## Washington Grove Connector – Crabbs Branch Way Extension Facility Planning Study Briefing

### **Staff Recommendation: Approval to Transmit Comments**

Staff recommends approval to transmit the following comments to the Montgomery County Department of Transportation:

Figure 2: Washington Grove Connector Trail Alternatives

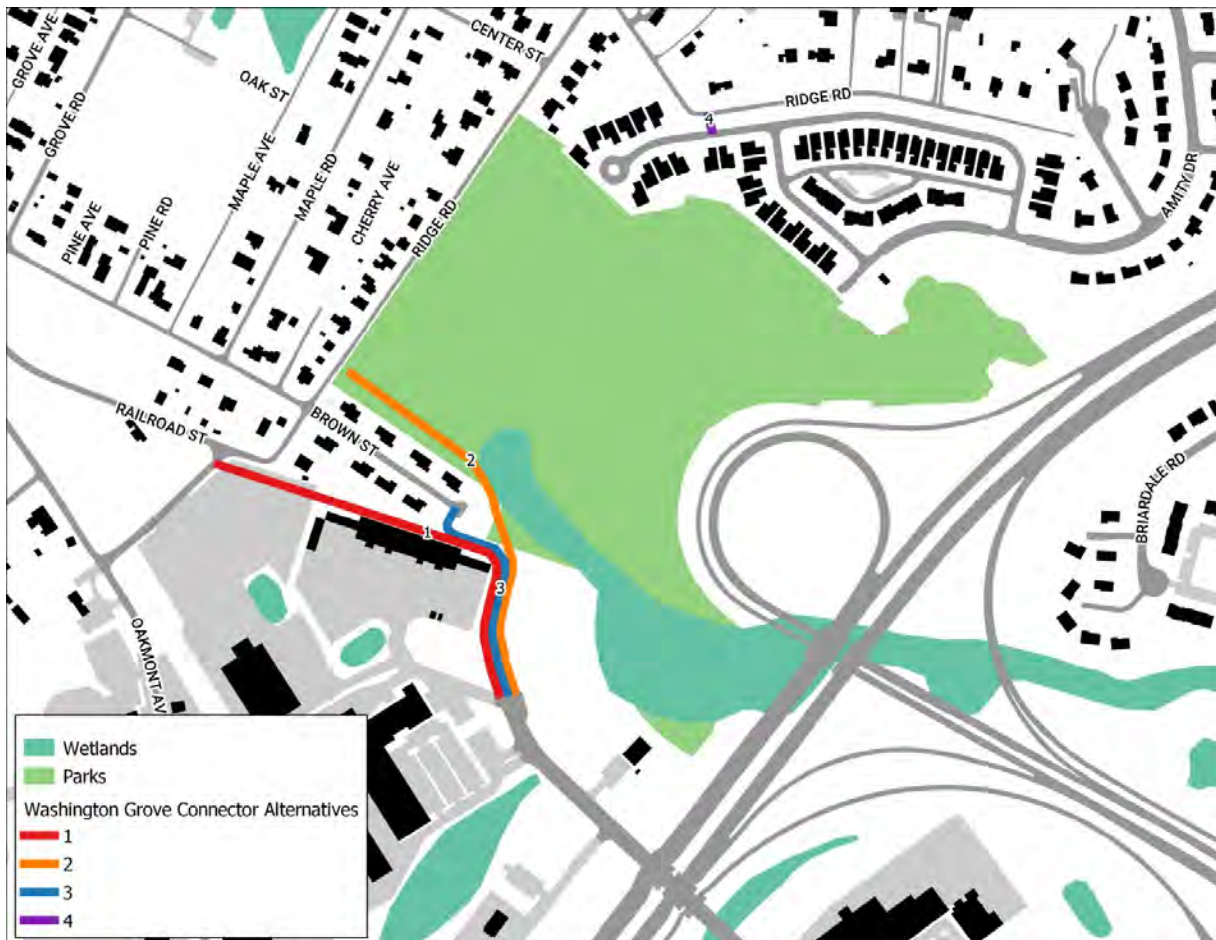
1. Washington Grove Connector Alternative #3 (Brown Street) should be advanced as the preferred trail alignment. This trail should be designed to county typical standards, including a trail width of ten feet with 2-foot wide unpaved, graded shoulders, and with no obstructions within two feet of the trail edge,

2. Washington Grove Connector Alternative #4 (Picea View Court Connector) should be advanced as an additional trail connection, as it has its own merits/independent utility for connecting the Amity Drive area with the Town of Washington Grove for pedestrians and cyclists,

Of the alternatives advanced by MCDOT, Montgomery Parks supports Alternative #3 (Brown Street) as the most effective connection from the Washington Grove neighborhood to the end of Crabbs Branch Way. This option provides an efficient connection while minimizing impacts to natural, cultural, and historical resources outlined. Alternative #2 is not supported due to the additional impacts this alignment presents to existing forest, wetland, and meadow habitat, and potential historic/archaeological resources.

Figure 6: Washington Grove Connector – Alternative #4 (Picea View Court)

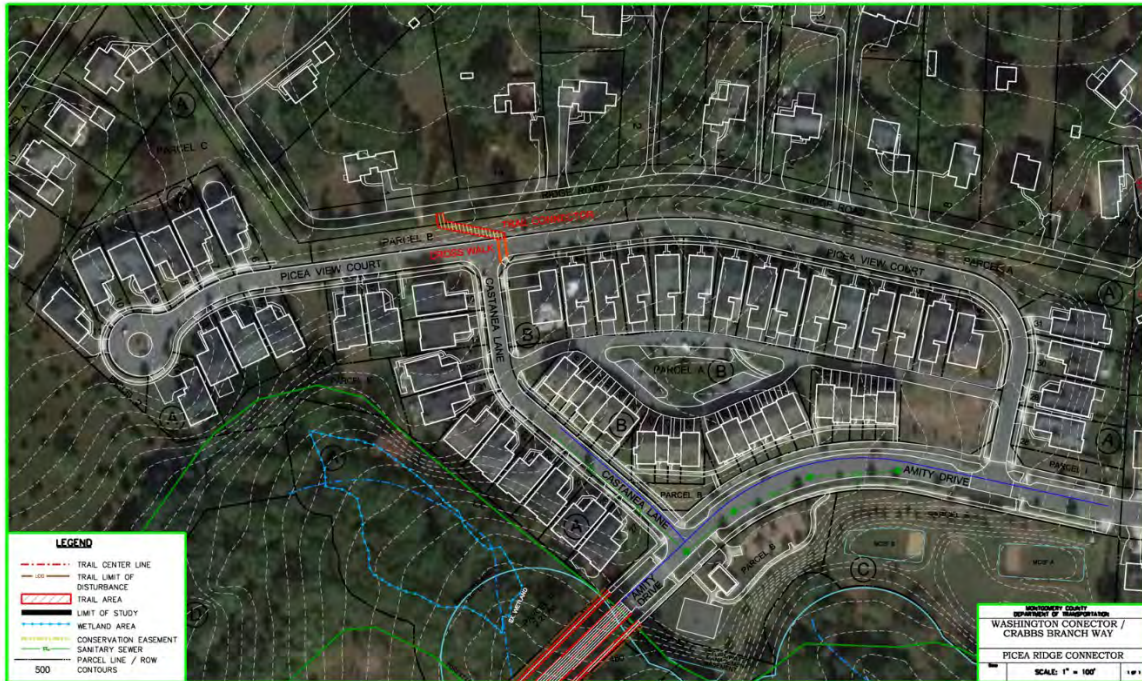
Table 1 presented below provides a summary of anticipated effects/impacts of three of the four alternatives. During MCDOT’s study, Alternative 4 was not evaluated in the same detail, and from a Planning Department perspective, seems to have independent utility compared to the three alternatives presented below. In general, of the three primary alternatives, Alternative #3 (Brown Street) has the lowest estimated construction cost, the shortest route, and the lowest impact to forested areas. It is also preferable to Alternative 1 because the street that it connects to (Brown Street) is lower volume than the street that Alternative 1 connects to (Railroad Avenue). All Alternatives provide acceptable slopes along the trails under consideration; however Alternative #1 (Railroad Avenue/ Roberts Oxygen) has the lowest maximum slope.

Figure 7: Crabbs Branch Way Extension – Plan View

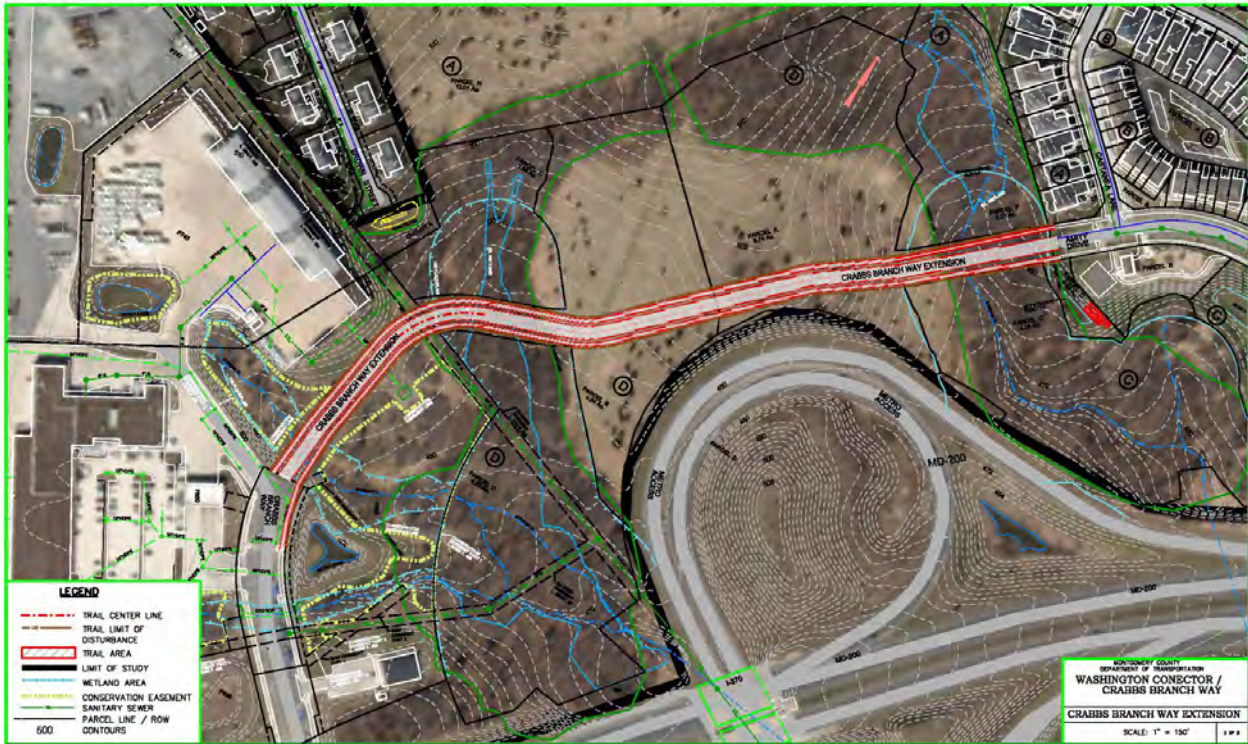
3. The cross section used to design the Crabbs Branch Way Extension should use the Neighborhood Connector street type presented in the Complete Streets Design Guidelines,

4. MCDOT should come back for a second briefing for the Crabbs Branch Way Extension project, once significant study and conclusions are reached for this facility planning study,

5. MCDOT should re-evaluate the need and alignment for the Amity Drive Trail Connector as presented in the briefing, as this connections could either be accomplished using the Crabbs Branch Way Extension alignment (if this road is constructed) or as a separate trail along generally the same alignment (if the road is not constructed). Montgomery Parks has concerns with the alignment shown during this briefing and has noted the existence of an unsigned, people's choice trail that would be preferable.

The Crabbs Branch Way Extension between Crabbs Branch Way and Amity Drive is master planned as a Primary Residential Street in the Master Plan of Highways and Transitways. This planned connection was included in the 2006 Shady Grove Sector Plan and has been continued as a recommendation in the recent 2021 Minor Master Plan Amendment. A trail facility called the Piedmont Crossing Local Park Trail is also master planned in the Bicycle Master Plan along the general alignment of this planned road connection. It should be noted that this planned extension would likely be re-classified as a Neighborhood Connector using the ongoing Complete Streets Design Guidelines. The typical cross section on this type of street would call for a sidepath on one side of the street (which would satisfy the Bicycle Master Plan trail connection), and a sidewalk on the other side of the street. The width of the travel lanes shown in the concept for this planned extension would also call for 11-foot wide travel lanes.

Alignment #3 – Brown Street

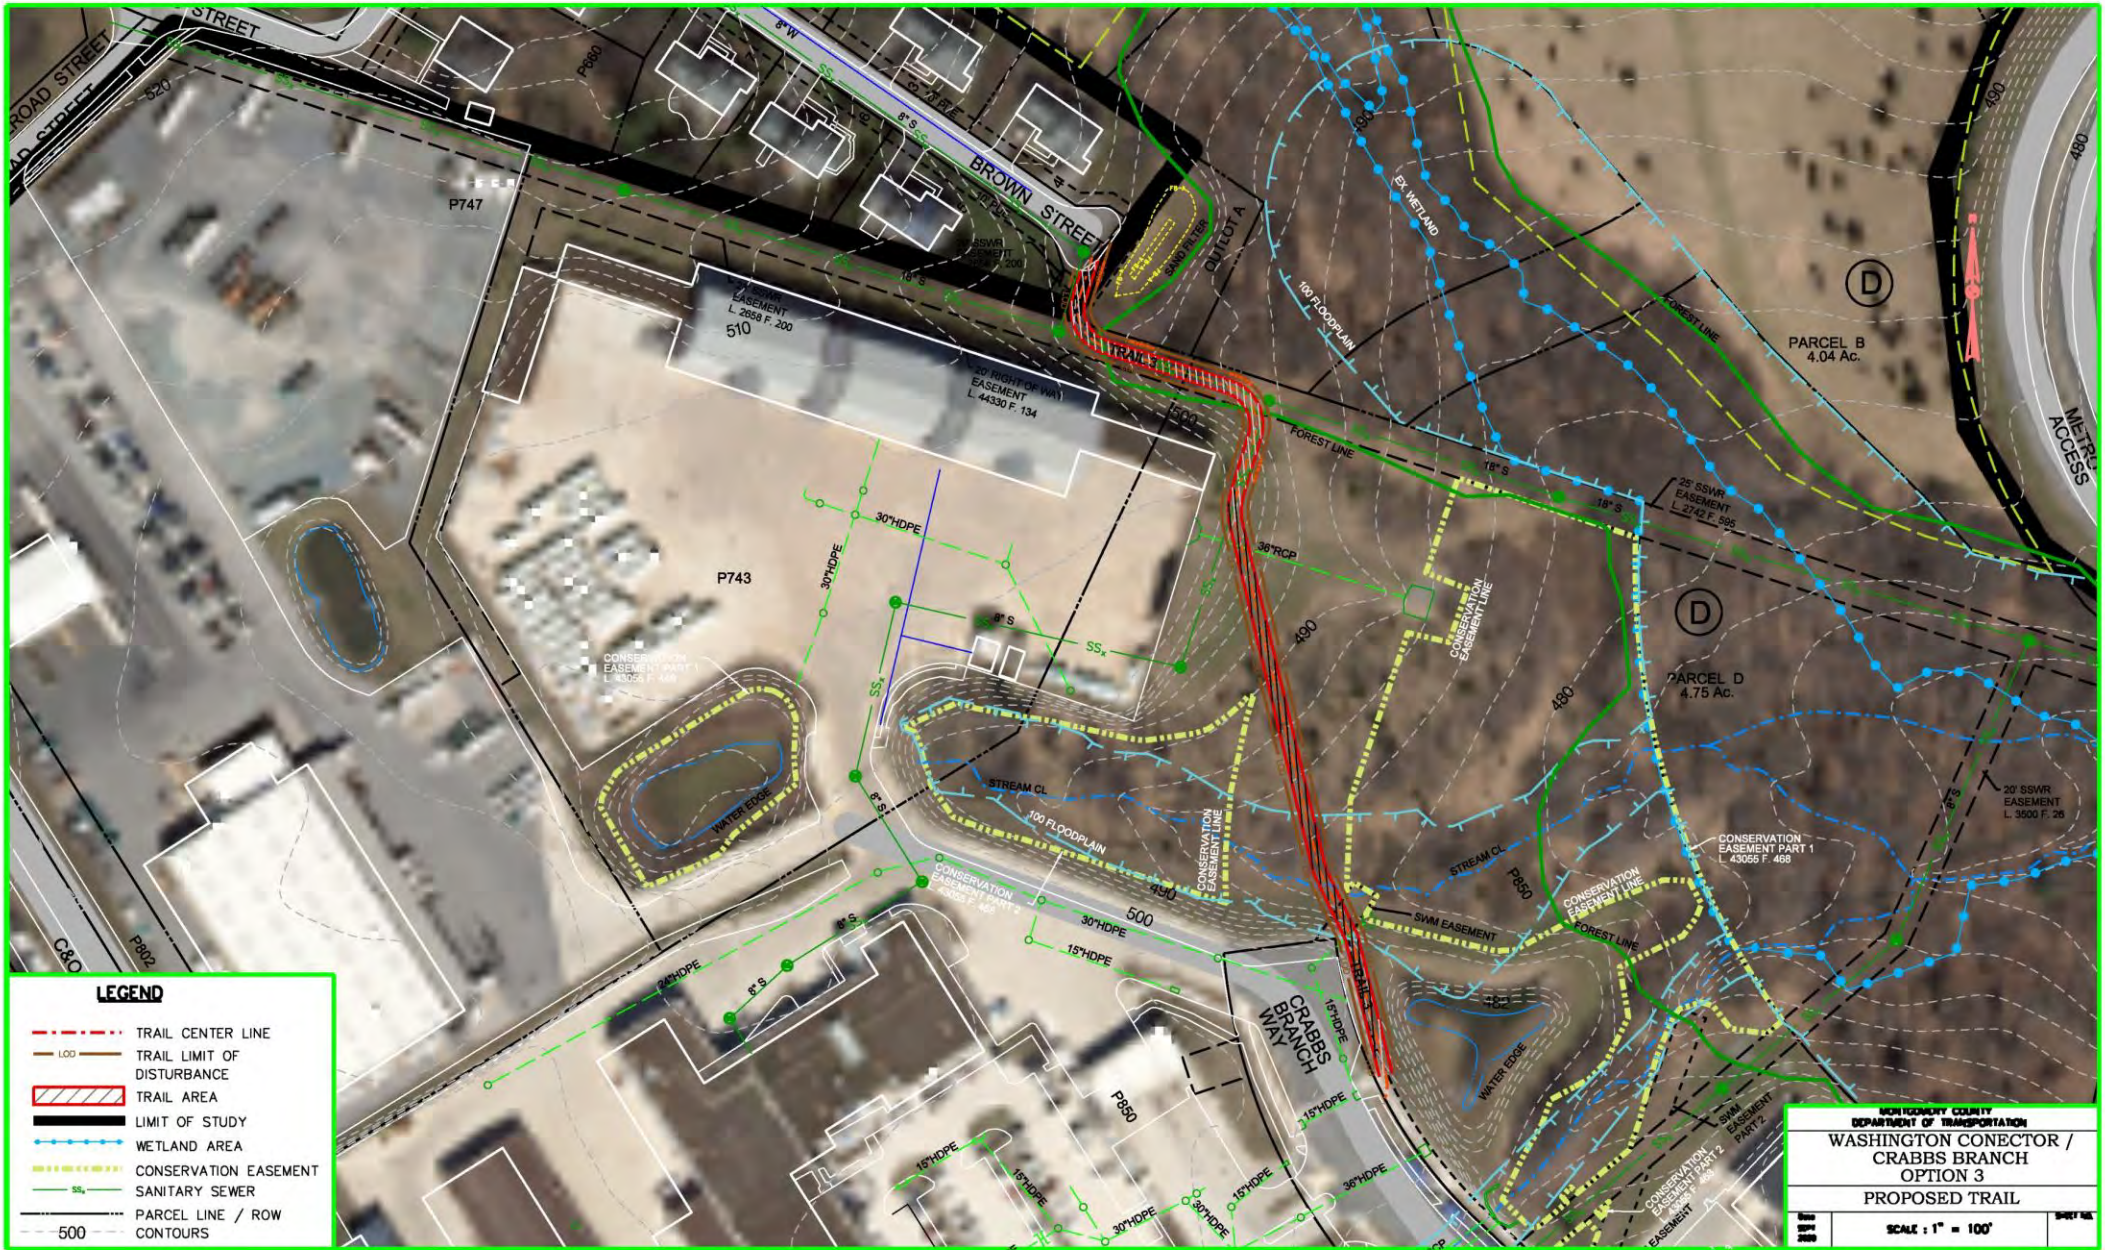
# Alignment #3 – Brown St Survey Comments

- Safest option
- Avoids backyards
- Shortest and least costly alternative
- Minimizes impact on trees
- Consistent with 1994 annexation agreement, adopted resolution, and conveyance of outlot
- Would increase traffic on Town of Washington Grove roads.

On March 8<sup>th</sup> the Washington Grove Town Council endorsed Brown Street (alignment 3) as the Town's preferred bikeway connection to Crabbs Branch Way. Thank you for the helpful interim findings the Study reported at the public meeting in February. With this action, the Council expresses support for recommendation of this alignment by the Washington Grove Connector Study, and for the County to proceed with detailed design and construction in the near future.

**CRABBS BRANCH WAY EXTENSION**

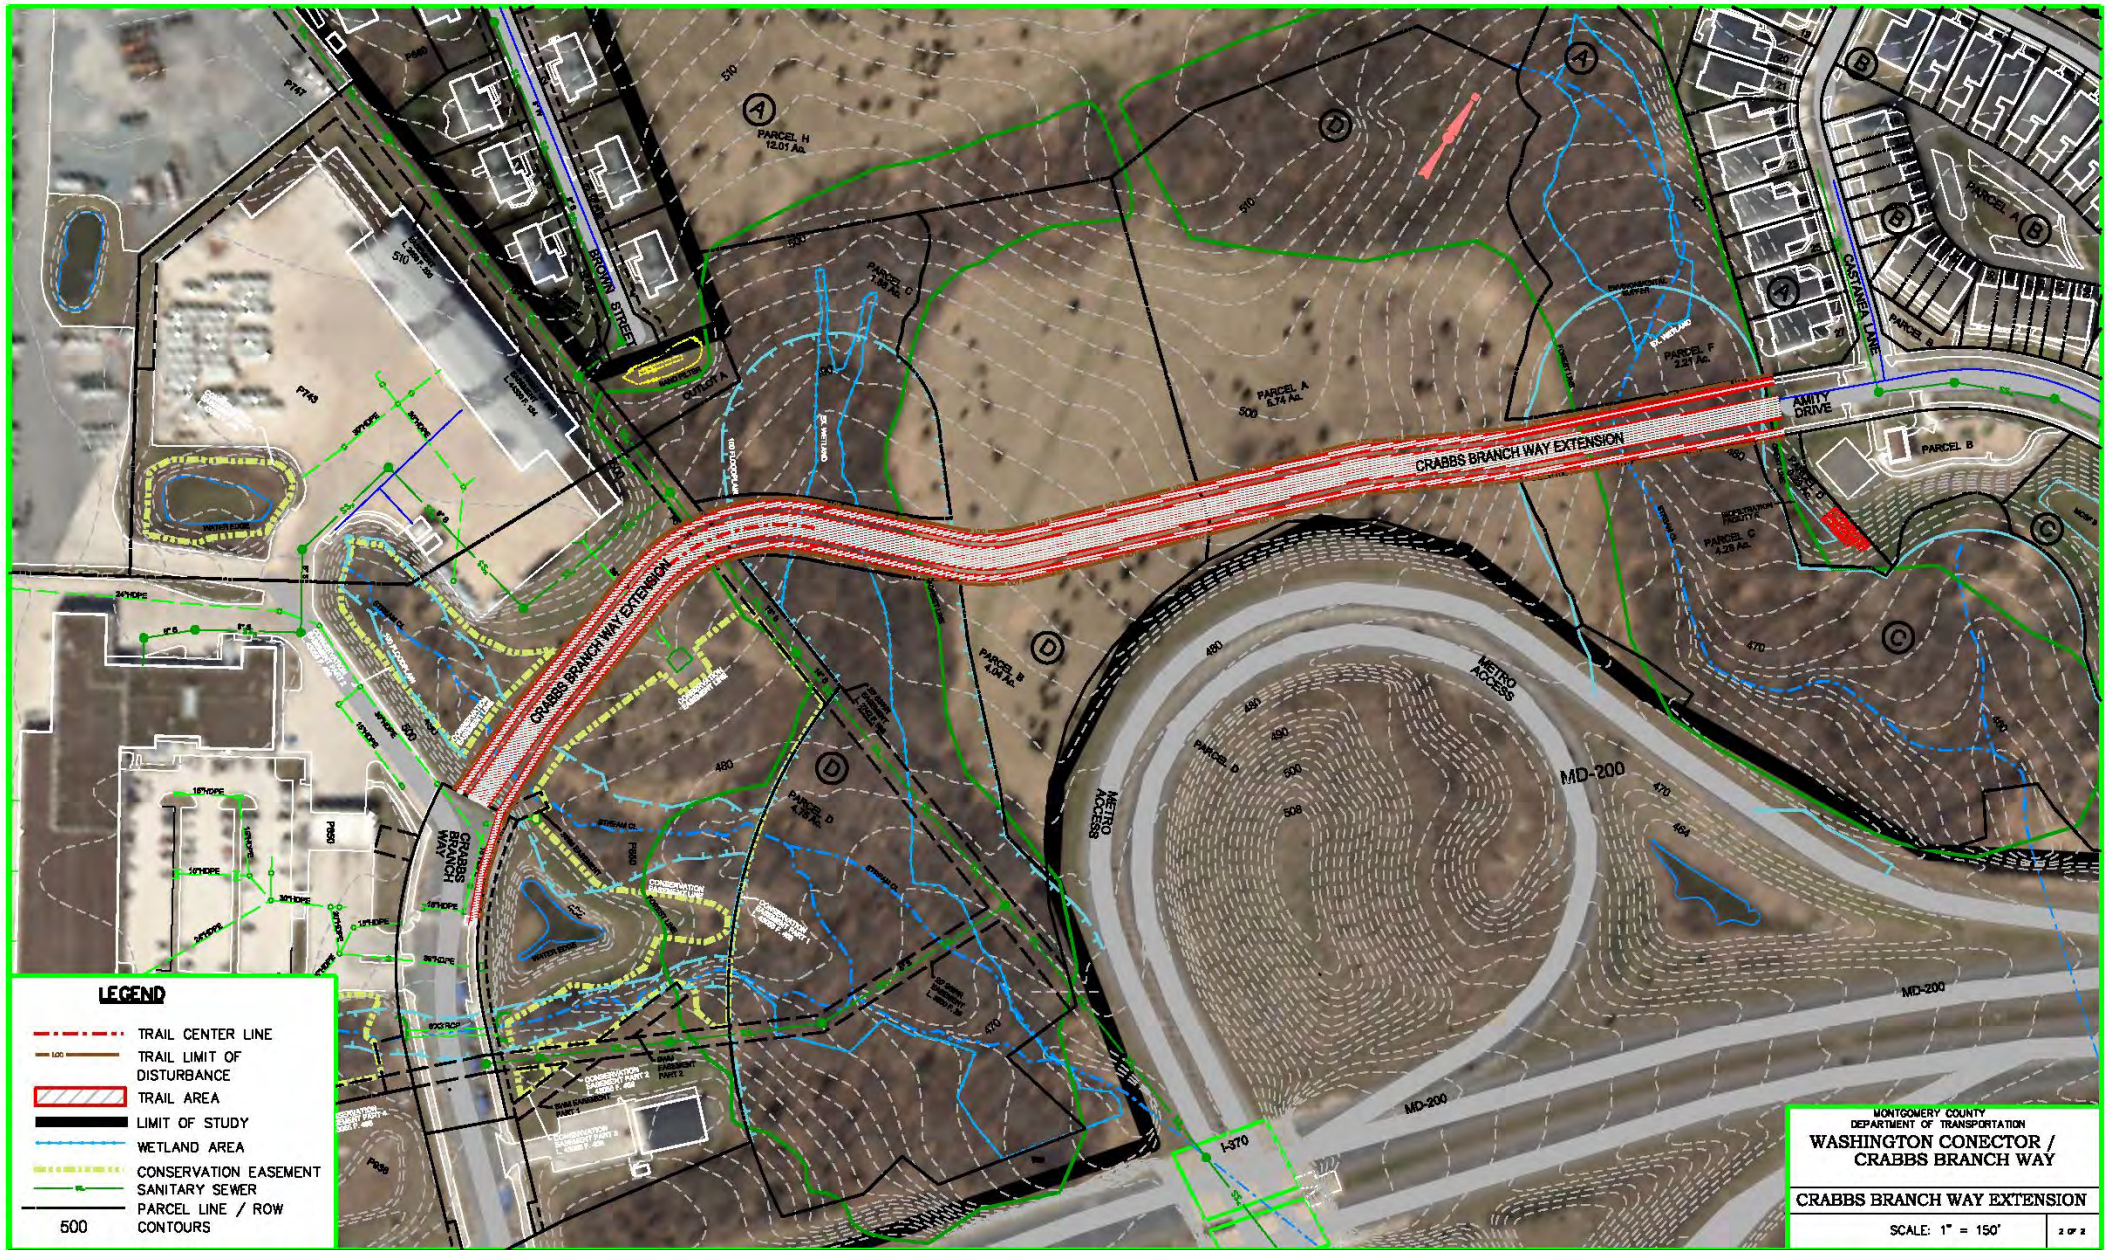
# Crabbs Branch Way Extension Survey Comments

- Increased traffic on Amity Drive
- Creates a new cut-through route
- Increased noise and light pollution
- Would destroy wildlife habitat
- Would reduce passive recreation area
- Would improve connectivity to Shady Grove Metro
- Access to Amity Drive Neighborhood Park would be more difficult with increased traffic
